# 2023/4757/P - Utopia Village, 7 Chalcot Road, London, NW1 8LH

<b>Delegated Report (Members Briefing)</b>		<b>Analysis sheet</b>		<b>Expiry Date:</b> 19/01/2024	
				<b>Consultation Expiry Date:</b> 31/12/2023	
<b>Officer</b>			<b>Application Number(s)</b>		
Ewan Campbell			2023/4757/P		
<b>Application Address</b>			<b>Drawing Numbers</b>		
Utopia Village 7 Chalcot Road London NW1 8LH			Please refer to draft decision notice		
<b>PO 3/4</b>	<b>Area Team Signature</b>	<b>C&amp;UD</b>	<b>Authorised Officer Signature</b>		
<b>Proposal(s)</b>					
Demolition of existing lean-to structures along the eastern boundary, erection of infill extension, alterations to the exterior of the building including replacement/alteration of windows and doors, removal of external services and plant, improvement of some external finishes, replacement of sections of roof, recladding of external stair case, installation of vents and over-cladding to plant room, refurbishment of bridge structure, installation of air intake/exhaust features associated with ventilation/heating/cooling systems, external courtyard landscaping works and replacement of entrance gates.

### PLANT SPACE FACADE DESIGN PROGRESSION

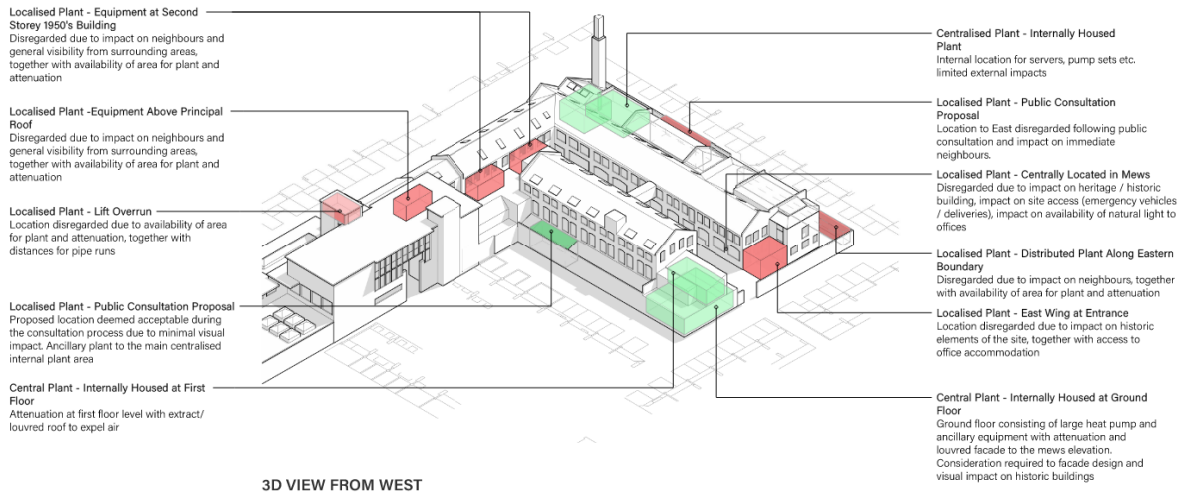
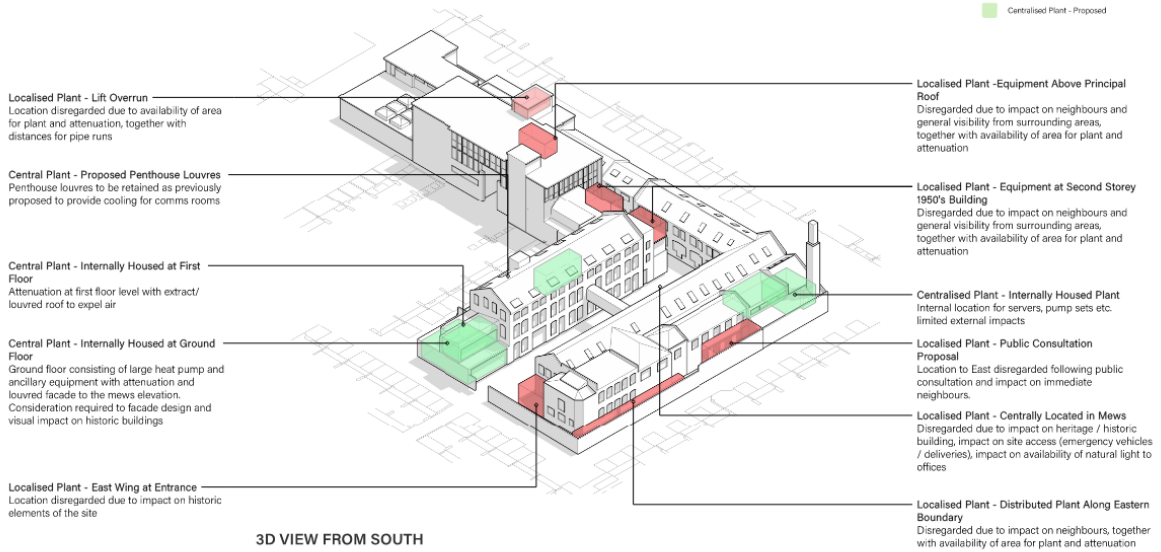
- Plant enclosure design amended with louvered wall terminals removed
- Window replacements reflecting original and traditional design
- Roof ridge vents changed

- 2.2.3. At the southern end of the historic buildings it is proposed to replace a modern two storey building with a large plant enclosure which will appear similar to the existing building in terms of scale and fenestration. The existing building is a rather bland 1950s structure with plain brickwork and strips of fenestration. Other than its scale and use of brickwork, it contributes little to the composition of Utopia Village. Whilst the refurbishment works mean it is similar in design and scale the finishes and materials are of higher quality and visually cleaner meaning that the replacement building is acceptable and preserves the character of the site and conservation area.
